CPED STAFF REPORT

Prepared for the Heritage Preservation Commission
 HPC Agenda Item #2
 July 26, 2016
 BZH-29220

Property Location: 201 Washington Avenue North
Project Name: Red Rabbit
Prepared By: Hilary Dvorak, Principal Planner, (612) 673-2639
Applicant: Luke Shimp
Project Contact: Adam Meyer with Studio M Architects
Ward: 3
Neighborhood: Downtown West; adjacent to North Loop
Request: To construct an addition to the existing building located at 201 Washington Avenue North

Certificate of Appropriateness	To allow an addition to the existing building located at 201 Washington Avenue North in the Warehouse Historic District
---------------------------------------	---

1 201 WASHINGTON AVE N - FLOOR PLAN
 Scale: 3/16" = 1'-0"

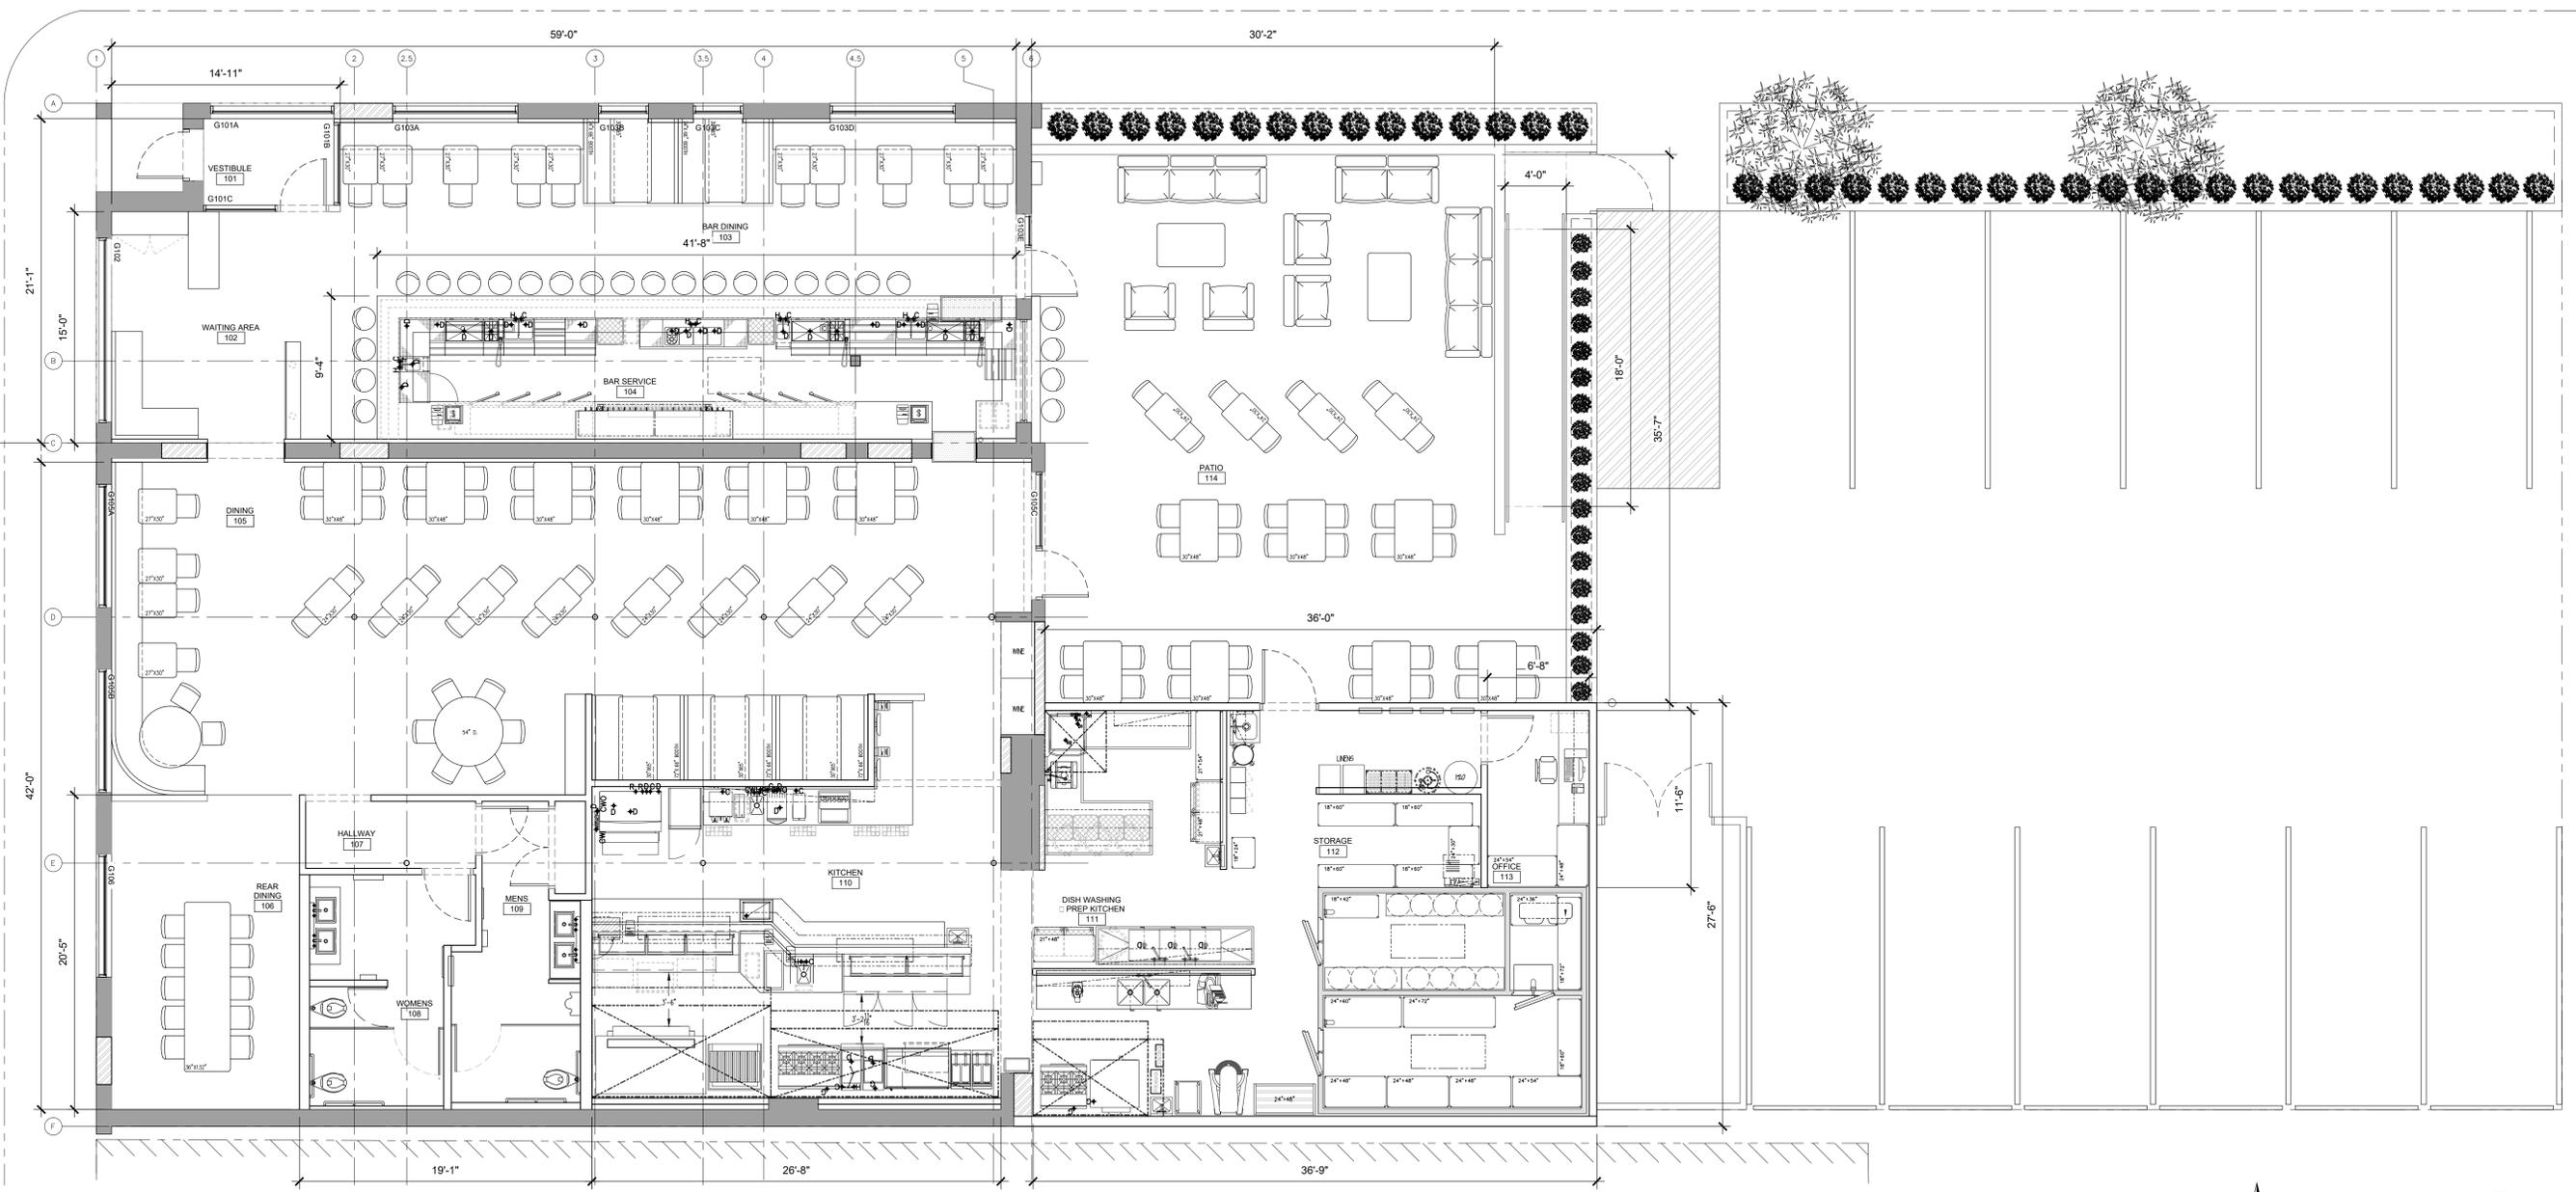
The existing building measures 66.5 feet by 61 feet. The proposed building addition measures 27.6 feet by 36 feet. The addition will be located towards the rear of the building; set back 36 feet from North 2nd Street. CPED is recommending that the addition be allowed to be set back from the street as the addition is located towards the rear of the building. In addition, between the building addition and the street there will be an outdoor patio enclosed with a three-foot tall cast-in place concrete screen wall that will help define the street edge.

SHEET TITLE:
EXTERIOR
ELEVATIONS

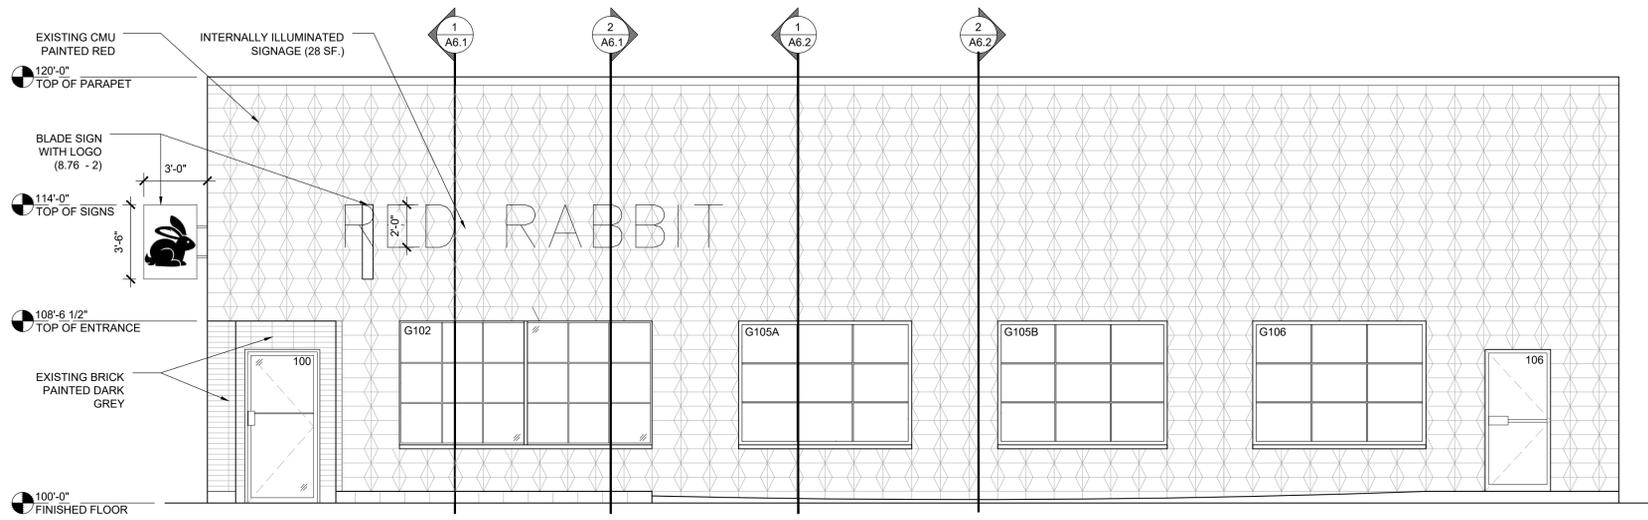
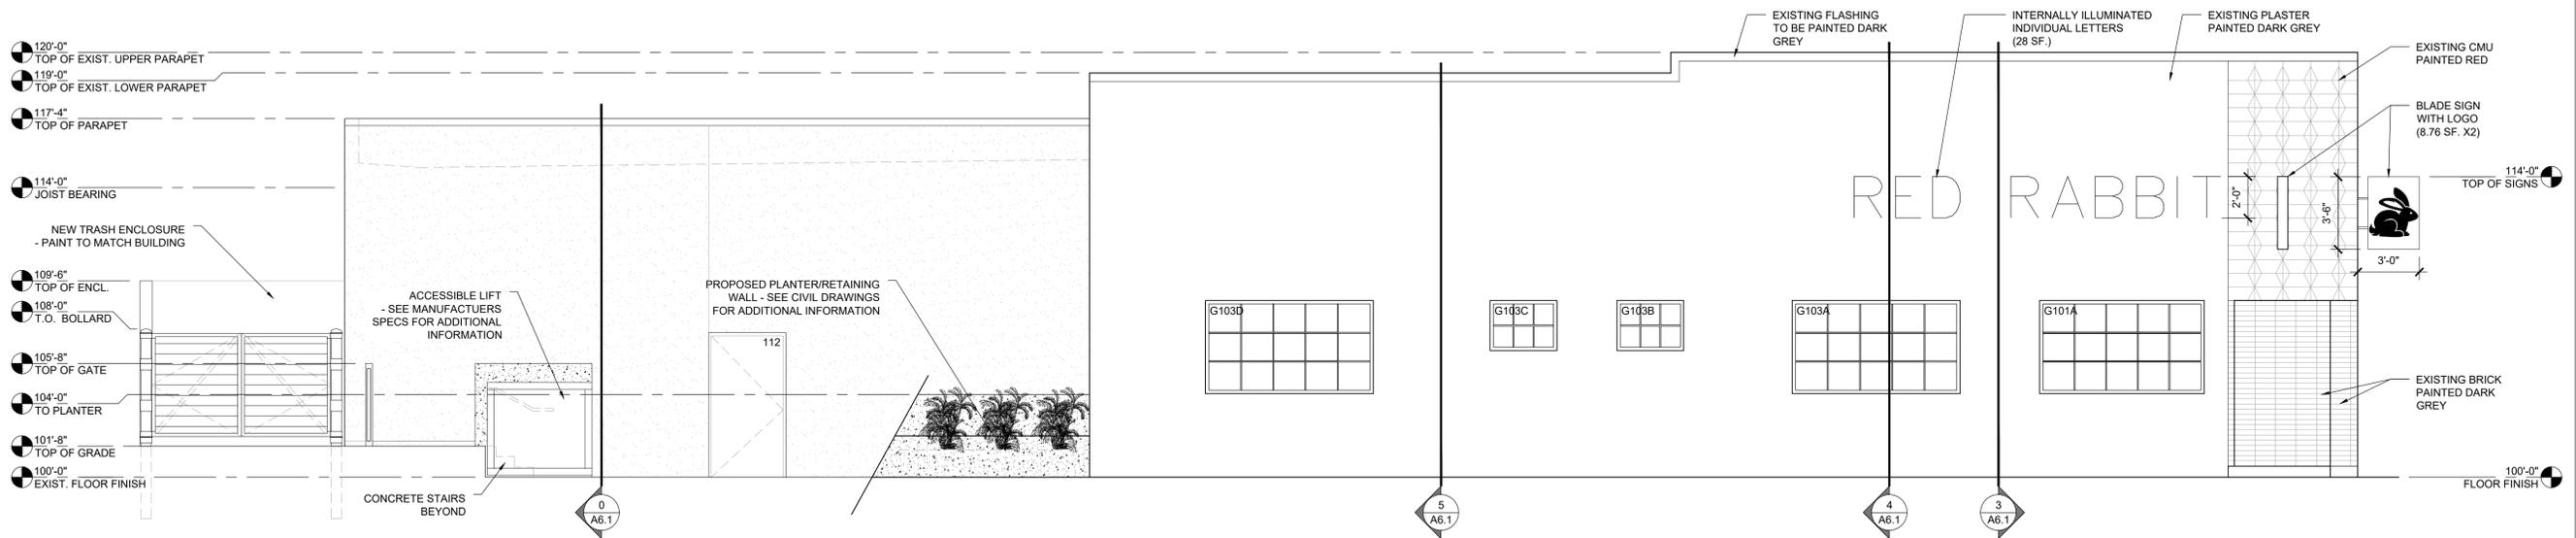
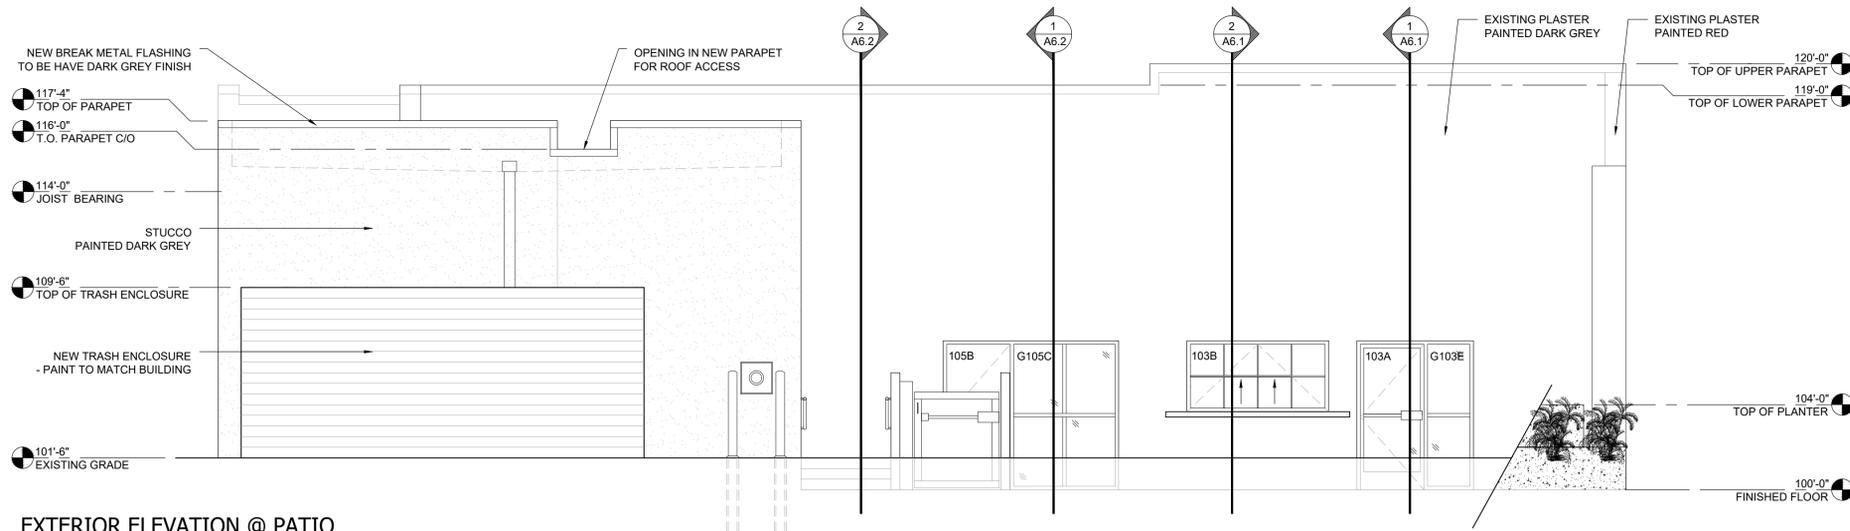
There is one horizontally aligned window located on the front façade of the building facing Washington Avenue North. The applicant is proposing to add three additional horizontally aligned windows on this façade. The total amount of windows on the Washington Avenue North façade will equal 19 percent of the total wall area. There is also one horizontally aligned window located on the secondary façade of the building facing North 2nd Street. The applicant is proposing to add four additional horizontally aligned windows on this façade. The total amount of windows on the North 2nd Street façade will equal 9 percent of the total wall area. The applicant is not proposing to have any fenestration in the addition facing North 2nd Street; however, the applicant is proposing to add fenestration to the rear façade of the existing building facing the proposed patio.

Additional fenestration could be achieved if vertically aligned windows were installed in the building. However, CPED is recommending that horizontally aligned windows be allowed to be installed in the existing building as that is what has always been in the building.

There is one horizontally aligned window located on the front façade of the building facing Washington Avenue North and there is one horizontally aligned window located on the secondary façade of the building facing North 2nd Street. CPED is recommending that horizontally aligned windows be allowed to be installed in the existing building as that is what has always been in the building. All of the windows in the building, existing and proposed, will be contemporary interpretations of commercial style windows with simulated division of light.

The existing entrances along Washington Avenue North will remain unchanged. A new entrance will be added along the rear façade of the building and another entrance will be added to the North 2nd Street façade of the addition. Both of these entrances will be rectilinear in shape and will be vertically proportioned.

The building is a one-story concrete block building. Stucco covers the North 2nd Street and rear elevations of the building. In addition, brick surrounds the principal entrance to the building located on the corner of Washington Avenue North and North 2nd Street. The applicant is proposing to clad the rear addition in stucco to match the existing building. Both the existing building and the addition will be painted.
